CITY OF SAINT PAUL
Christopher B. Coleman, Mayor

DATE: February 19, 2015

TO: Planning Commission

SUBJECT: *West Side Flats Master Plan and Development Guidelines* – Summary of Public Testimony and Committee Recommendations

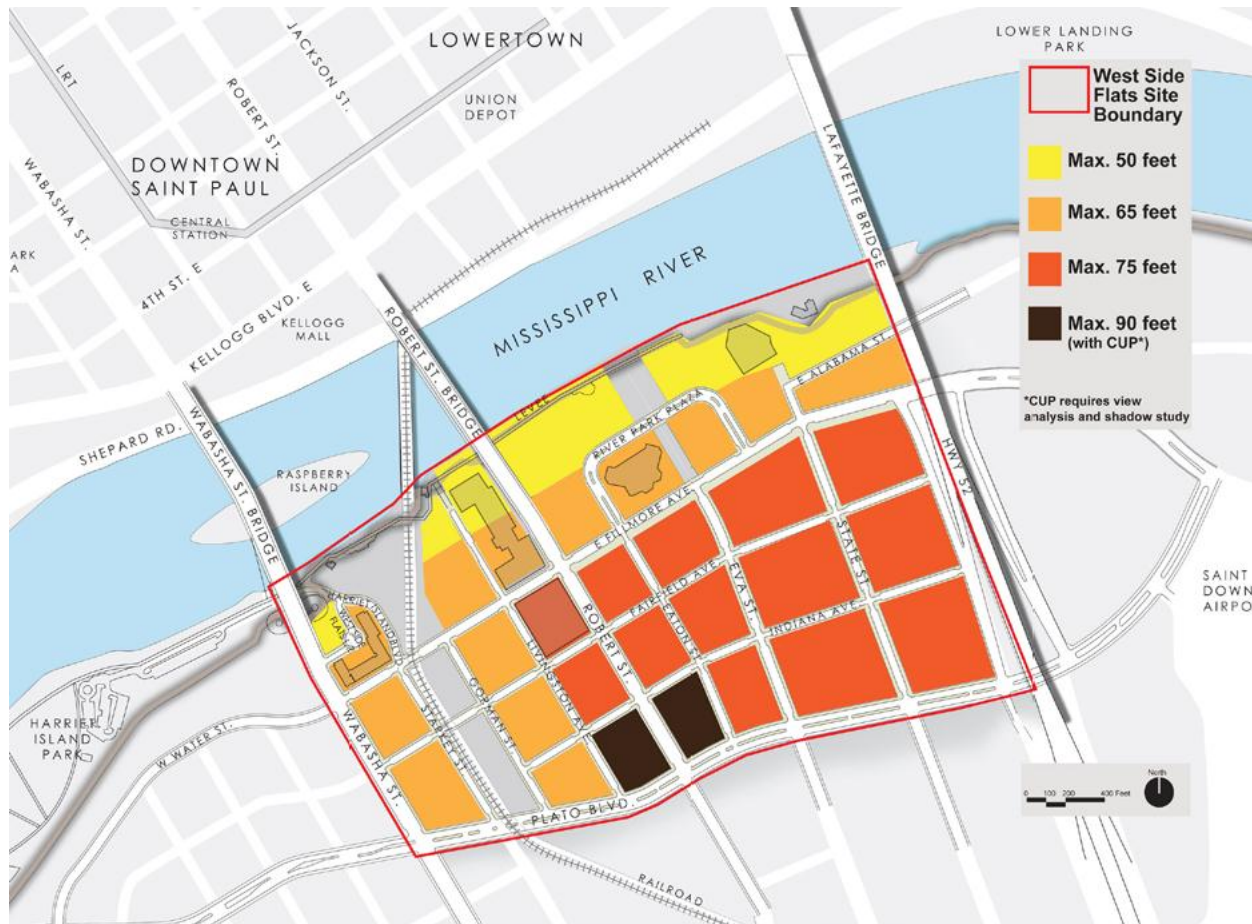
Most of the opposition to the draft Master Plan was presented by current or past employees of Rexam. They stated strong concern that the Rexam building is not shown on the Illustrative Plan on pg. 64, and that it is replaced with Eva Street Park and three new streets. Although the draft Master Plan states that the construction of new streets and parks throughout the planning area would be likely only in conjunction with private redevelopment; that parcels can be put to any legal use permitted under current zoning until such time as the City has the resources to build the recommended streets and parks; and that infrastructure changes in the area east of Robert and south of Fillmore are likely to occur in Phase IV (of IV, 20-30 years out), Rexam employees feel the future of their company is threatened. Most of the Rexam speakers asked that the Phase IV improvements be deleted from the Master Plan.

1. Remove the proposed streets and park east of Robert Street between Fillmore Avenue and Plato Boulevard from the Master Plan base map, which would remove them from all of the individual master plans (land use, urban design, acceptable building heights, street system, transit system, pedestrian and bike circulation, parks and open spaces, green infrastructure and public art) as well as the Illustrative Plan. The Illustrative Plan would show existing buildings and streets east of Robert between Fillmore and Plato, with a “bubble” explaining future strategies to pursue as redevelopment occurs in this area. As an example, a revised Street System Plan and Illustrative Plan are attached showing how the maps would look with these changes.

2. Keep the area east of Robert and south of Fillmore in Implementation Phase IV (20-30 years), but replace the bullets on page 108 of the draft Plan with the following bullets:
